March 15, 2023

Georgia Environmental Protection Division
Land Protection Branch
4244 International Parkway
Atlanta Tradeport, Suite 104
Atlanta, Georgia 30354

RE: Mining Land Use Plan Permit submitted by Twin Pines Minerals, LLC for Saunders Demonstration Mine in Charlton County, application number **SAS-2018-00554-SP-HAR**

Image 4 Trail Ridge Land, LLC property (in yellow) in Charlton County with flooding filter enabled. Source: Charlton County Tax Assessors website.

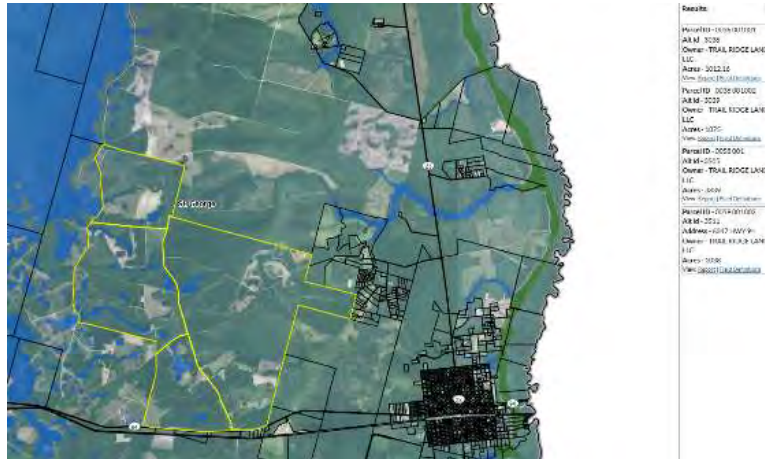
TPM owns nearly 8,000 acres (including the proposed demonstration mine) from Highway 94 northward (Image 4).¹¹ If this mine is permitted, TPM will likely seek future permits to mine the remaining acres they currently own. The northwestern corner of their property comes within 400 feet of the Okefenokee Swamp, half a mile from the Refuge property, and north and west of the St. Marys River.¹²

Has the additional site south of Highway 94 been taken into consideration in regards to plans to be reviewed and wastewater storage capacity? Sheet 5 of the MLUP 2a, Note 1 of Mining Sand Process Flow Diagram, states that “All material shall be hauled, utilizing trucks, between the permitted mine, wet processing areas, and Mineral Separation Plant (MSP) south of Highway 94.¹³” The Mineral Separation Plant that is located outside of the permit boundary¹³ is currently owned by Sharon Bell and Eli L. Padgett¹¹. **Is the use of this Mineral Separation Plant to be approved as part of this permit?** Additionally, Note 2 of Sheet 5 states “Process water shall be piped to the MSP from Management Pond 3 (M3). Any wastewater from the MSP shall be hauled by tanked trucks, to the processing ponds for re-use¹³” (Image 5). **Are there plans showing the pipes that connect M3 to MSP? How much wastewater is expected to be produced from the MSP and has that been included in the water budget of the process ponds?**

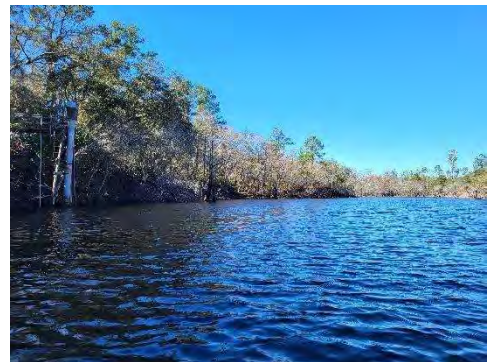
The Moniac gauge is located in the channel of the North Prong and the river itself is narrow (Image 6a) while the Macclenny gauge is located along the shore and the river is roughly 150 feet wide (Image 6c). The tributaries that flow into the St. Marys River between the two gauges change the volume of water which changes the width of the river. The 160 square mile drainage area of the North Prong is fed entirely by the Okefenokee Swamp and surficial aquifer. In contrast, the drainage area of the Macclenny gauge is 4.4 times larger (700 square miles) and includes a larger area of influence from the surficial aquifer and a dozen tributaries, three of which are over 20 miles long with their own headwaters.¹⁵ With a substantially larger drainage area into the St Marys River in the downstream portion around Macclenny, there is the potential for increased variability in measured streamflow at this gage compared to the Moniac gage, where river inputs are fewer. As the Okefenokee swamp is drought sensitive, minor alterations to water inputs in the area may have a disproportionate impact, and monitoring only based on the Macclenny gage may obscure or minimize negative effects to the Okefenokee and headwaters of the St. Marys River.

Riverkeeper does not agree with EPD’s decision to solely use the Macclenny gauge. Based on a letter signed by more than ten research hydrologists of southeastern universities “the appropriate USGS gauge for assessing hydrologic effects on the Okefenokee Swamp of consumptive groundwater withdrawals...is North Prong of the St. Marys River at Moniac, GA.¹⁷” Furthermore, USGS has stated that “EPD is using USGS’s quality rating system incorrectly to make its gage-decision.¹⁸”

To accurately determine how water withdrawals from the surficial aquifer will impact the St. Marys River at its source, the Moniac gauge must be monitored. In addition to this, water levels and water flow in the main stem St. Marys River must also be monitored. Therefore, it is the recommendation of Riverkeeper that three gauges be monitored and recorded to fully understand the impacts of water withdrawal from the Floridan and surficial aquifer on water flow to the Swamp and/or St. Marys River: Moniac, Macclenny, and Traders Hill Boat Ramp. In addition, a water level gauge and water quality monitoring device should be installed on the St. Marys River downstream of the mouth of Boone Creek.

Image 7 Site layout including the locations of the eight water ponds on the property (permitted boundary is indicated in red). The Four Management Ponds (M1-M4) are indicated in blue in the upper right quadrant and the four processing ponds are south of the Management Ponds.

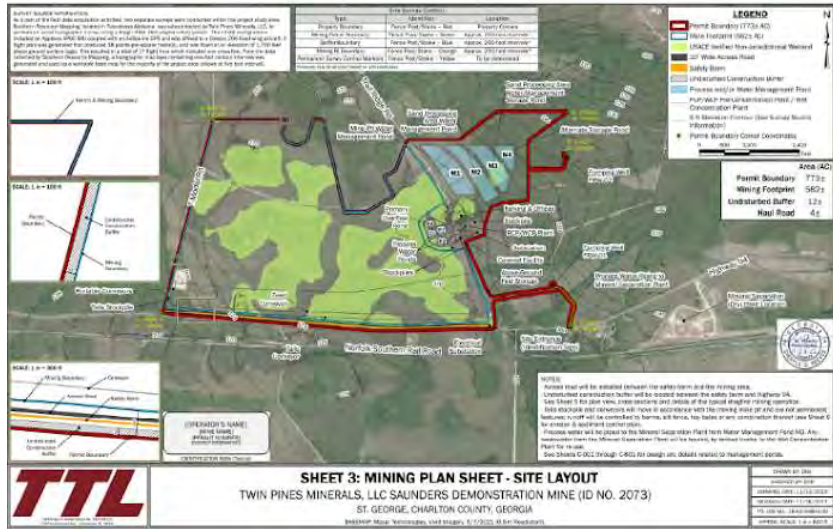
Each pond is diked around the perimeter as well as in between each pond, ponds M1-M3 have an overflow section 2 feet below the top of each berm, and there is a large quantity of floating evaporators to expedite the evaporation process.

The berms along the edge of the ponds and in between each pond will be made of soil from the surrounding soils (presumably from the dugout ponds) which will be returned to the excavated hole once the ponds are decommissioned.²⁰ Each pond will be lined with a double sided textured high density polyethylene geomembrane on bedding layer²¹ to prevent stored water from seeping back into the soil compromising the structural integrity of the berms. Each berm will be inspected daily using Georgia Safe Dams inspection checklist.²² If a berm needs repairing, TPM states “the pond associated with the berm can be dewatered and repaired.”²⁰ **Can the other berms withstand the additional volume of water added by an out-of-commission pond? What is the backup plan if the remaining ponds do not have the capacity or are in fact compromised themselves and cannot take in additional water? How is the liner going to be inspected and repaired?**

Flow between the ponds will be controlled by sluice gates and the overflow section will pass water to the lower adjacent pond once water elevation exceeds overflow elevation.²⁸ M4 does not have an overflow section to an adjacent pond as it is designed to be the alternate storage pond if the other 3 ponds reach high water levels. **What is the plan if M4 overflows? Where will overflow discharge occur?**

Image 8 Description of sediment barrier along perimeter of permitted boundary.

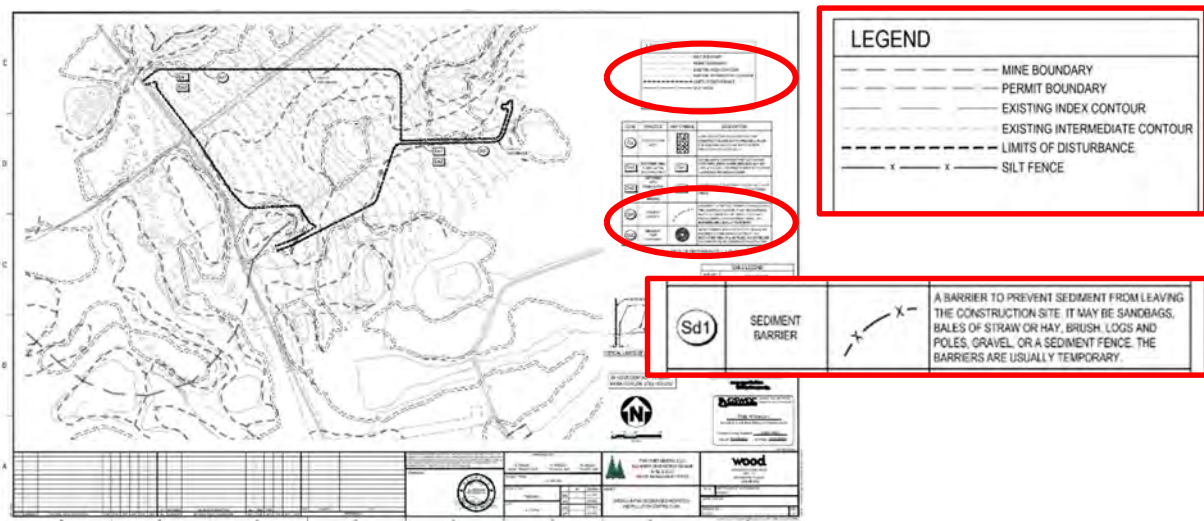
Sediment Control is unclear and concerning and could affect the pristine quality of the upper St. Marys River. A silt fence is proposed along the perimeter of the pond area, 2 feet before the permitted boundary.²³ The locations of sediment control are either Sd1-BB – Brush Barrier or Sd1-S – Silt Fence. Sd1- BB is the only designated silt fence around the M1 – M4 ponds, below Ponds 1-4 and the Plant area where there are major natural contour changes and some near off site natural wetlands. The sediment barrier Sd-1 is to ‘prevent sediment from leaving the construction site, it may be sandbags, bales of straw or hay, brush, logs and poles, gravel, or a sediment fence. The barriers are usually temporary’ (Image 8).²³ Also, M1 - 4 is a pond area constructed by a huge amount of dirt relocation and diking. MLUP Sheet 7 details Silt Fence Type C with “height” to be shown on erosion, sedimentation, and pollution control plan.” There is no height designation for silt fencing found on the plan as referenced. Also on Sheet 7 is the detail for Brush Barrier “with minimum base width of 5’ and no wider than 10’ and “filter fabric may be placed on the side...”²⁴ However, details for a fabric silt fence placed 2 feet from the limits of disturbance are mentioned in the Legend. **Why only place a Brush Barrier around Ponds M1 – M4, P1- P4 and the Plant? Or is it to be a fabric silt fence, and at what height? If a Brush Barrier, how does the base width fit into the permit area? What is the height of the silt fence around the mining area?**

If a berm collapses during a heavy rain event, is the expectation that this silt fence will prevent the turbid water from entering and contaminating neighboring properties and local waterways? Will the company be implementing silt fence Stormwater Best Management Practices based on EPA’s document EPA 833-F-11-008²⁵? How will the fencing be placed? How long is each fence run? Will there be an overlap between runs? How has the drainage area been evaluated to determine efficiency and quantity of the silt fences? What is the silt fence made of? The silt fence design and installation is unclear.

The silt fencing is on the outside of the perimeter roadway and berm meaning there is a long steep slope for sediment runoff. EPA’s silt fence BMP states that “When there is a long steep slope, install one fence near the head of the slope to reduce the volume and velocity of water flowing down the slope, and another fence 6–10 ft from the toe of the slope to create a sediment storage area near the bottom.²⁷” The size of the drainage area for the management pond is not provided indicating that the site has not been evaluated for this necessary and critical piece of equipment.

It is the recommendation of Riverkeeper that TPM consult EPA’s silt fence BMP document to determine the drainage area to properly install the appropriate material, quantity, and design of silt fencing. In addition, TPM should install two silt fences to prevent sediment from flowing outside of the permitted boundary, and a buffer of 25 feet should be required between the furthest out silt fence and the permitted boundary to provide an extra level of protection for the surrounding area.

Image 9 Wetland delineation map in proximity to the Management and Processing Ponds in the northeast quadrant of the permitted property. Berms and silt fencing come within 25 feet of a wetland in the northwest corner of M1. A stream of concern flows under the berm in M4.

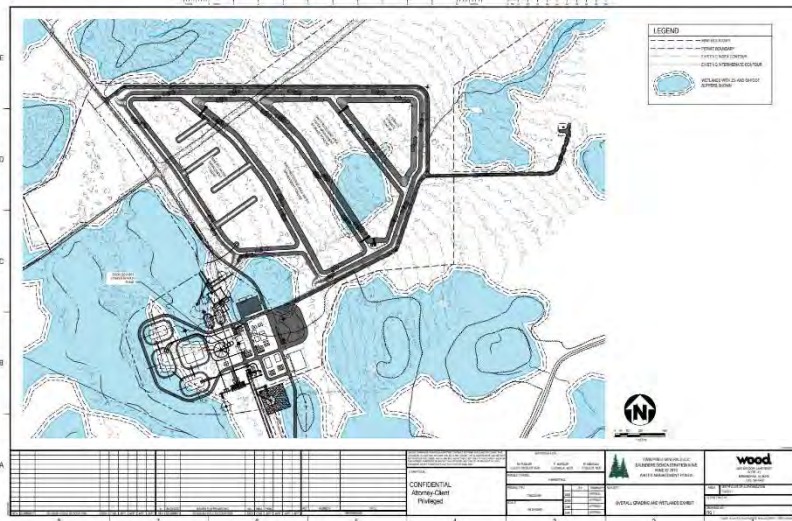
In the wetland delineation map (Image 9), there are two waterbodies in close proximity of the Management Ponds that are of concern.²⁶ The first water body originates under the perimeter berm of the M4 pond. Although this pond is the alternate storage, any leaks from the liner or berm collapse will directly impact this waterbody and downstream. The second waterbody that is of concern is the northwestern corner where the permitted boundary comes within 25 ft of the wetland. Within the wetland is another stream that could be directly impacted from a contamination discharge. **Are the wetlands that are outside of the permitted boundary northwest and east of the Management Ponds considered jurisdictional under the new rules?**

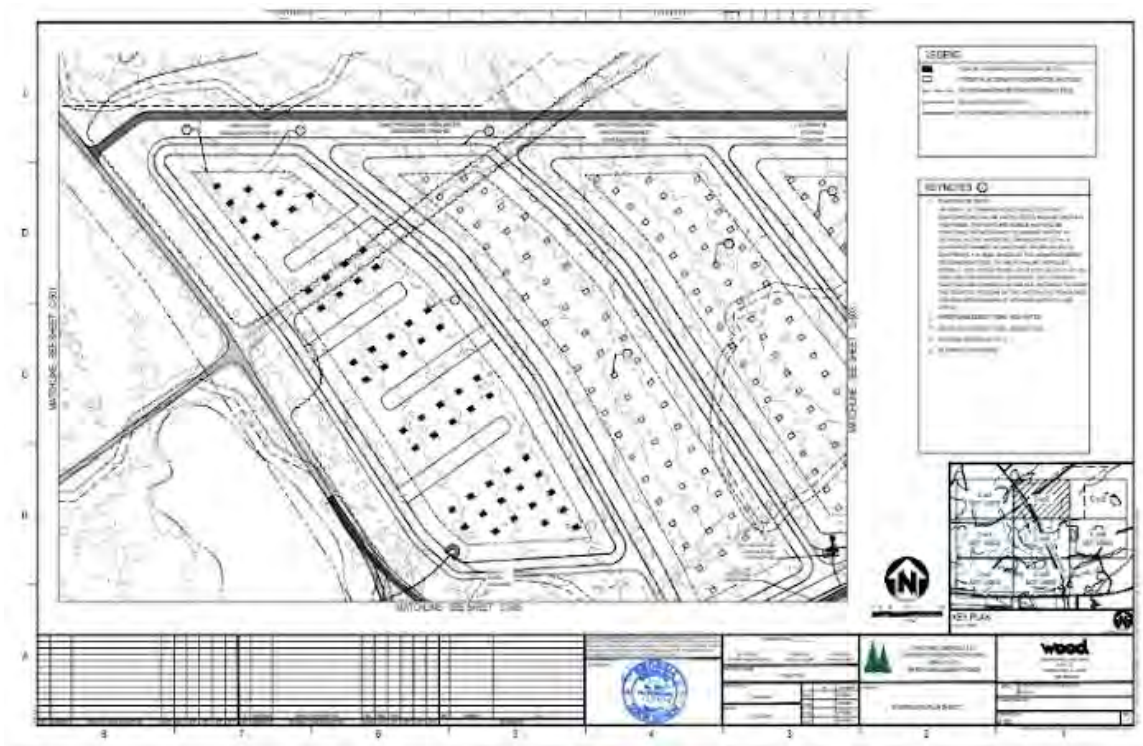
The MLUP 2b shows the locations of the evaporators in the 4 Management Ponds. There is a discrepancy of the number of evaporators that will be used. The Legend states that Pond M1 will have 55 Evaporators and their locations are depicted below but the additional evaporator locations in M2-M4 are called ‘Potential Alternative Evaporator Locations’.

In the Key notes, it states that “ ...in the water use management Plan, a sufficient number of units will be installed to evaporate 1.44 mgd. Based on the manufacturer’s recommendations, 167 units will be installed initially with 26 additional units being installed if needed³²” (Image 10). **Why is TPM installing only 55 evaporators when the manufacturer recommends installing 167 to meet the goal of evaporating 1.44 mgd?**
